Department of Energy  
Washington, D.C. 20545  
Docket No. 50-537  
HQ:S:82:157

ADDITIONAL INFORMATION FROM NOVEMBER 22-24, 1982, MECHANICAL ENGINEERING  
BRANCH (MEB)/CLINCH RIVER BREEDER REACTOR PLANT (CRBRP) MEETING

Enclosed are a new Preliminary Safety Analysis Report (PSAR) Table 3.2-4  
and an amended PSAR Section 4.2 that respond to MEB items 3 and 41 from  
the reference letter. This information will be incorporated in  
Amendment 75 to the PSAR scheduled for January 1983.

UPDATE TO PSAR CHAPTER 4

Figure 4.2-43. Removable Radial Shield Assembly

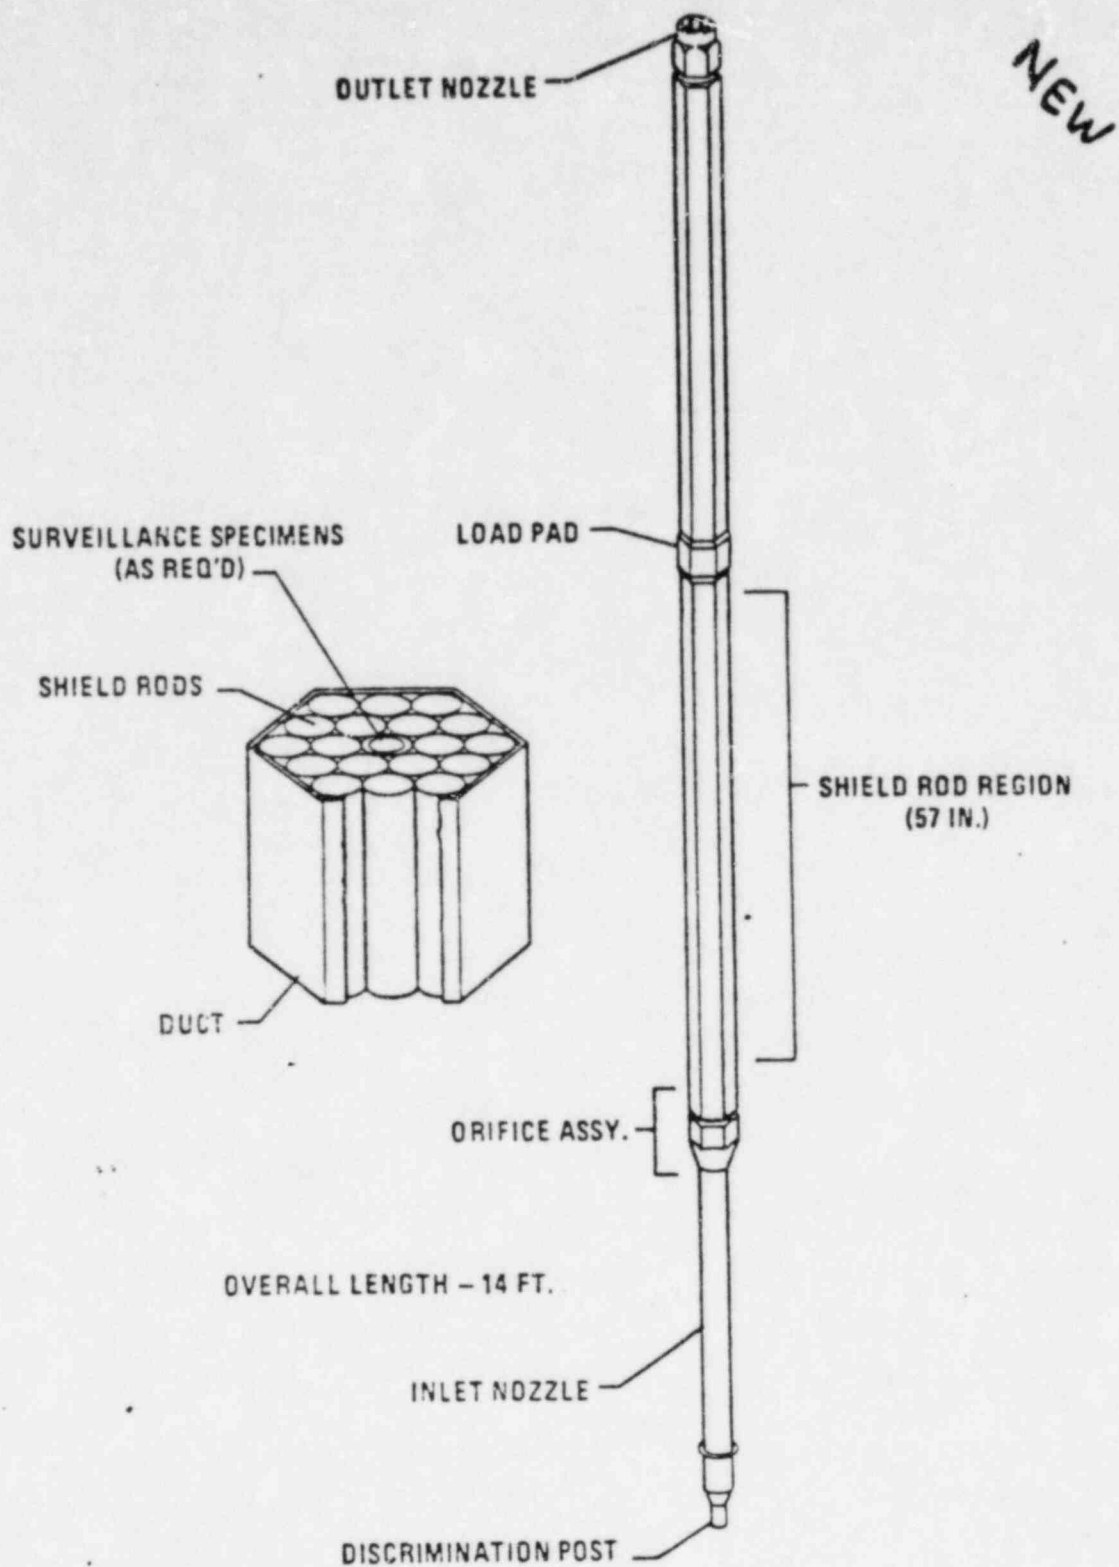
The removable radial shield assemblies are core assemblies (See Figure 4.2-43) which mechanically interface with the radial blanket assemblies, the core former structure, the lower inlet modules, the bypass flow modules, and the upper internals. These assemblies have the following functional requirements:

The RSS assemblies are removable core assemblies (See Figure 4.2-43) having a structure basically similar to the fuel and blanket assembly structures consisting of inlet nozzle, hexagonal duct tube and outlet nozzle

The RRS configuration is shown in Figure 4.2-43. The structural analyses included two critical regions of the RRS, the Above Core Load Pad (ACLP) of the duct and the outlet nozzle. The selection of these two regions was based on structural analyses of the basically similar fuel and blanket assemblies which indicated that the assemblies inlet regions comprising the inlet nozzle, orifice assembly and transition had very high design margins, while operating under more severe environmental conditions than the RRS. The above mentioned structural analyses indicate that the ACLP is the critically loaded region.

4.2-43	Removable Radial Shield Assembly	4.2-528
4.2-43A	Loading Histogram Used in Inelastic Analysis of RRS ACLP	4.2-528a

Figure 4.2-4.3A. Loading Histogram Used in Inelastic Analyses of RRS ACLP

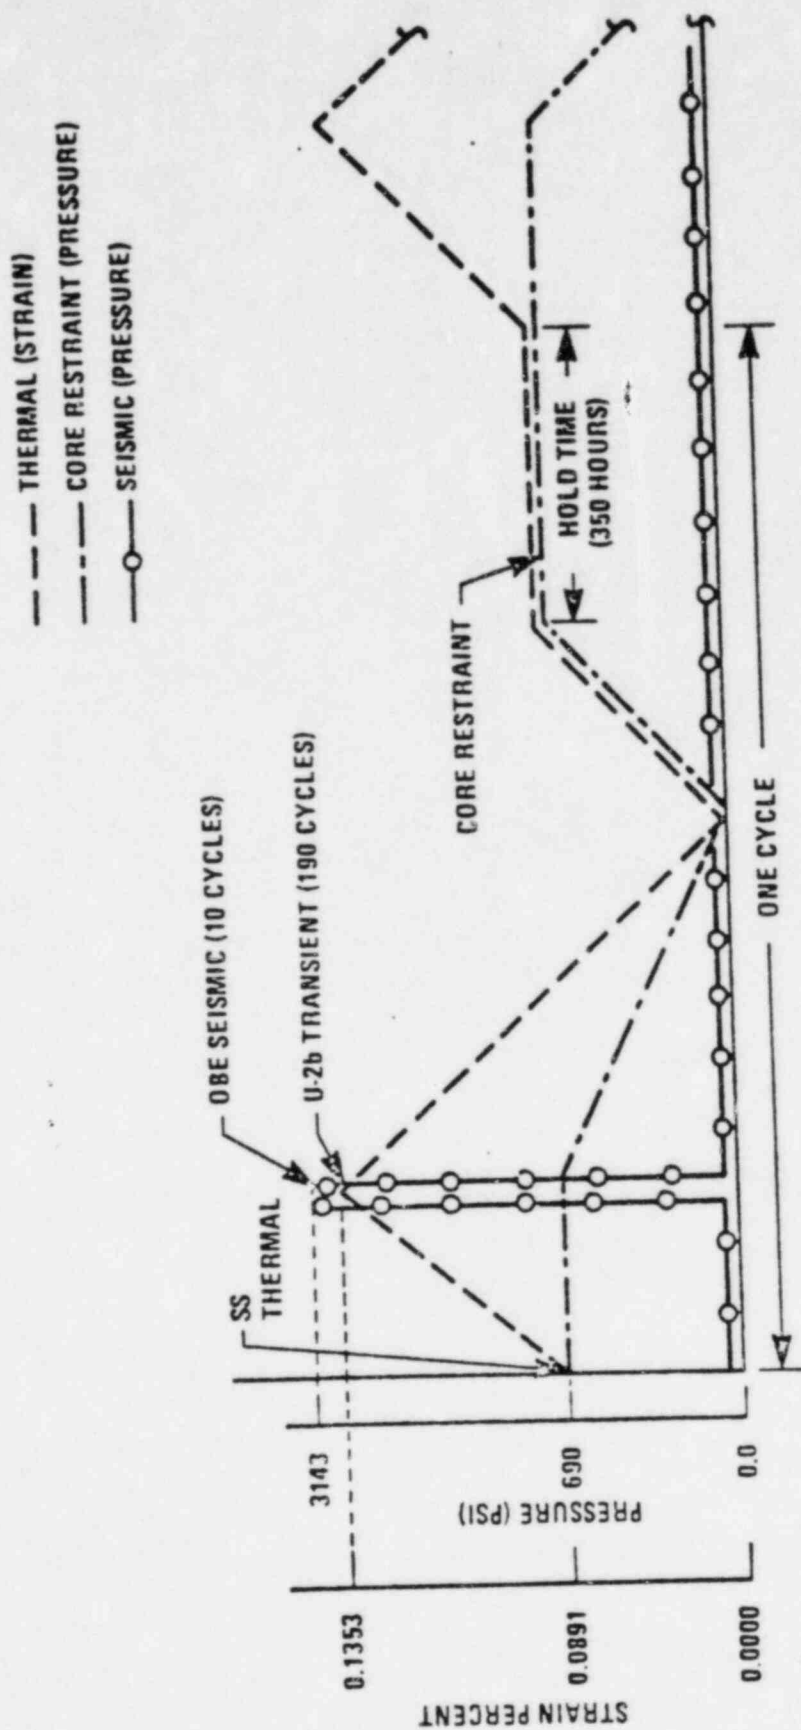
In the ACLP analyses, maximum values from all loading sources were assumed to occur simultaneously at the single assembly subject to the worst environmental conditions. The various loading conditions considered were seismic, core restraint, and steady state and transient thermal loads. Three different sets of thermal-hydraulic conditions were considered from which the worst combinations of maximum duct midwall and cross-duct gradient temperatures was obtained. Stresses, strains and damage were determined for the ACLP resulting from the above loading sources and conditions.

The inelastic analyses were performed to determine strain and damage of the ACLP using the CHERN elastic-plastic-creep computer program. Two separate sets of analyses were performed, one representing BOL conditions, and one representing EOL conditions corresponding to a design life of 10 years. Twenty out of the 190 loading cycles of the unit histogram (see Figure 4.2-43A) were run for each of the two conditions to overcome the transient portions of the elastic-plastic-creep domain, and the remaining 170 cycles were conservatively duplicated by the 20<sup>th</sup> cycle. Both the calculated total maximum strain and the calculated maximum creep-fatigue damage when compared with the minimum allowable values yield positive design margins equal to 14.0 and 0.14, respectively.
